SUMMARY OF NOVEMBER 2018 REVISIONS - VERSION 3.2.5.0

Since the release of BRADD Version 3.2.4.3, several operational issues have been addressed. This release of BRADD Version 3.2.5.0 contains the following revisions:

BRIDGE AUTOMATED DESIGN AND DRAFTING SOFTWARE

Example of a detail with MicroStation Complex Dimension Elements created using MicroStation CONNECT Update 9

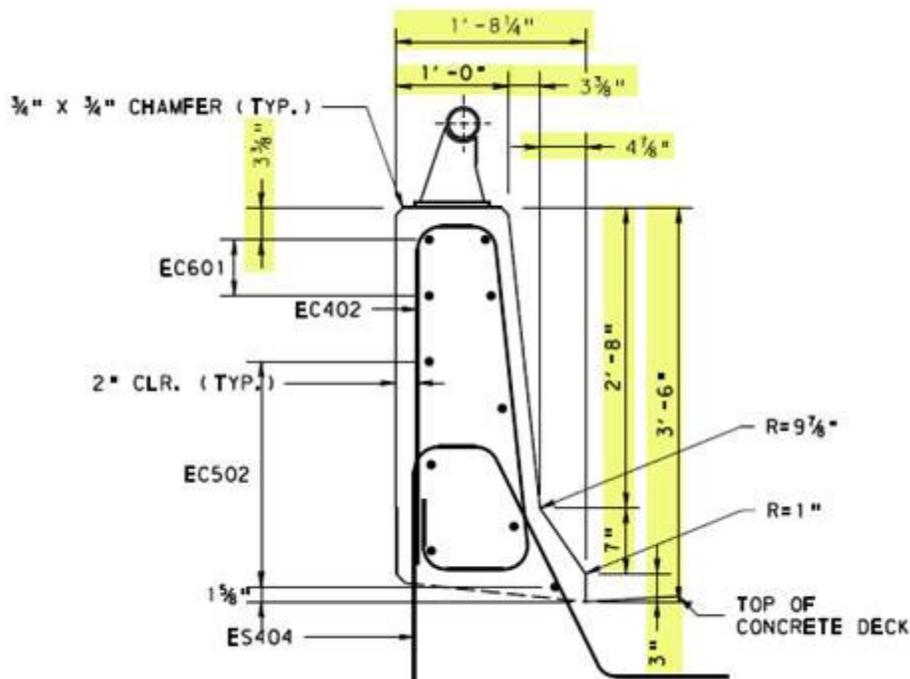
11. The calculation of the protective coating quantity for Integral Abutment approach slabs has been added to BRADD. (TFS 5050)
12. MicroStation Complex Dimension Elements have been implemented in BRADD for linear dimensions placed with text aligned with the dimension line, provided MicroStation CONNECT (version Update 9 or later) has been used to generate the drawings. Almost all of the BRADD linear dimensions have been converted (approximately 91% of the coded linear dimensions) to MicroStation Complex Dimension Elements where the components of the linear dimension act as one object making it easier to edit. Previously, all the components were placed as separate objects for all linear dimensions in BRADD. The remaining coded BRADD linear dimensions will be converted in a future BRADD release. (TFS 5119)

Example of a detail with MicroStation Note Elements created using MicroStation CONNECT Update 9

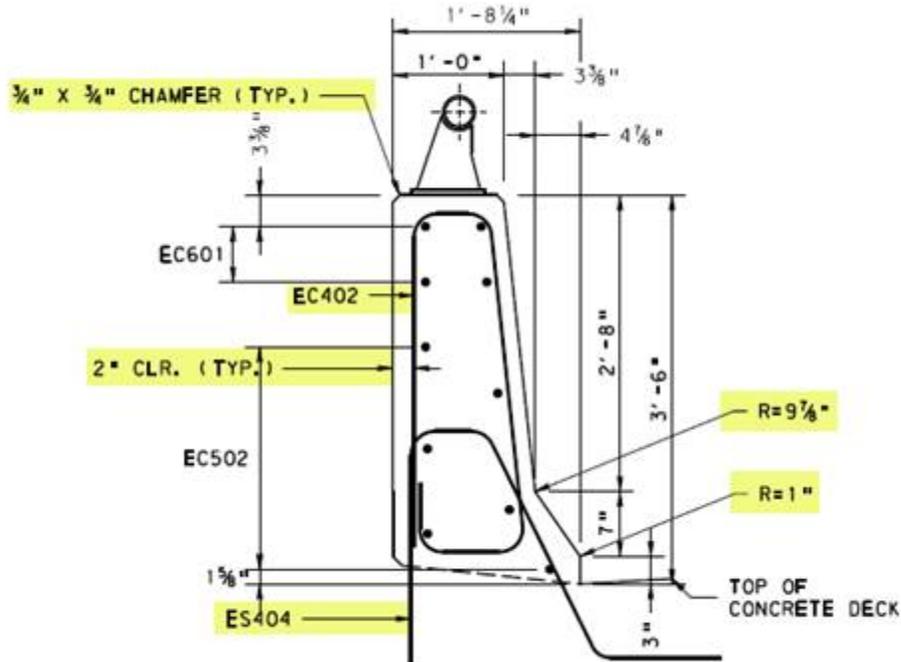
14. The MicroStation Place Note element has been implemented in BRADD when MicroStation CONNECT (version Update 9 or later) is used to generate the drawings. This means that a leader line with text will be treated as a single element that can easily be edited in MicroStation CONNECT. Previously, a leader line with text were placed as separate elements. (TFS 5121)
